Access Compliance Report

Public Rights-of-Way

(Pedestrian Signals)

Intersection ID: N/A	Main Street:	Cross Street: N/A	Location: N/A
ADA ID: E161AB75DBBC	Signal Type: One Push Button-Non APS	Overall Compliance: No	Severity Score: BTN 1: N/A BTN 2: N/A No BTN: N/A
Codes/Mitigation Info/Possible Solution		Field Measurements/Component Compliance

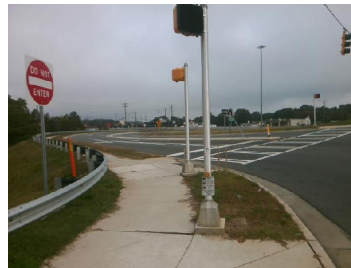
PROW/ADA: R209.1, TMUTCD 4e.08, R404.2, R404.3, R406.2

Compliance	Description	Data	Compliance	Description	Data
	Button Count	Button1	Yes	Distant to Additional Button (in)	180.0
	Additional Button Present?	Yes		Additional Button ID	07BFD2FAD2F99
N/A	Signal Buttons Required?	N/A	N/A	Additional Ped Posts Required	N/A
	How Many Ped Street Xings?	1		Located In An Island/Median?	No
N/A	B 1 Sign Present?	Yes	N/A	B 2 Sign Present?	N/A
Yes	B 1 Sign Purpose?	Yes	N/A	B 2 Sign Purpose?	N/A
Yes	B 1 Sign Lettering & Contrast?	Yes	N/A	B 2 Sign Lettering & Contrast?	N/A
No	B 1 Parallel To XWalk?	No	N/A	B 2 Parallel To XWalk?	N/A
Yes	B 1 PAR to Button?	Yes	N/A	B 2 PAR to Button?	N/A
Yes	B 1 PAR to XWalk?	Yes	N/A	B 2 PAR to XWalk?	N/A
Yes	B 1 Clear Floor Space?	Yes	N/A	B 2 Clear Floor Space?	N/A
N/A	B 1 FWD Approach?	Yes	N/A	B 2 FWD Approach?	N/A
N/A	B 1 FWD Approach Constrained?	No	N/A	B 2 FWD Approach Constrained?	N/A
No	B 1 FWD Approach Reach (in)	5.0	N/A	B 2 FWD Approach Reach (in)	N/A

N/A	B 1 FWD Approach Width (in)	N/A	N/A	B 2 FWD Approach Width (in)	N/A
N/A	B 1 FWD Approach Obstruction?	Yes	N/A	B 2 FWD Approach Obstruction?	N/A
N/A	B 1 FWD Approach Obstruction Dist (in)	1.0	N/A	B 2 FWD Approach ObstructionDist (in)	N/A
N/A	B 1 PARA Approach?	Yes	N/A	B 2 PARA Approach?	N/A
N/A	B 1 PARA Approach Constrained?	No	N/A	B 2 PARA Approach Constrained?	N/A
Yes	B 1 PARA Approach Reach (in)	5.0	N/A	B 2 PARA Approach Reach (in)	N/A
N/A	B 1 PARA Approach Width (in)	N/A	N/A	B 2 PARA Approach Width (in)	N/A
N/A	B 1 PARA Approach Obstruction?	Yes	N/A	B 2 PARA Approach Obstruction?	N/A
N/A	B 1 PARA Approach Obstruction Dist (in)	1.0	N/A	B 2 PARA Approach ObstructionDist (in)	N/A
No	B 1 Clear Floor Space Slope (%)	3.8	N/A	B 2 Clear Floor Space Slope (%)	N/A
No	B 1 Clear Floor Space XSlope (%)	3.7	N/A	B 2 Clear Floor Space XSlope (%)	N/A
N/A	B 1 PAR Slope (%)	0.7	N/A	B 2 PAR Slope (%)	N/A
Yes	B 1 Height (in)	32.0	N/A	B 2 Height (in)	N/A

Possible Solutions: Provide Push Button Extension. Remove and Replace Clear Space.
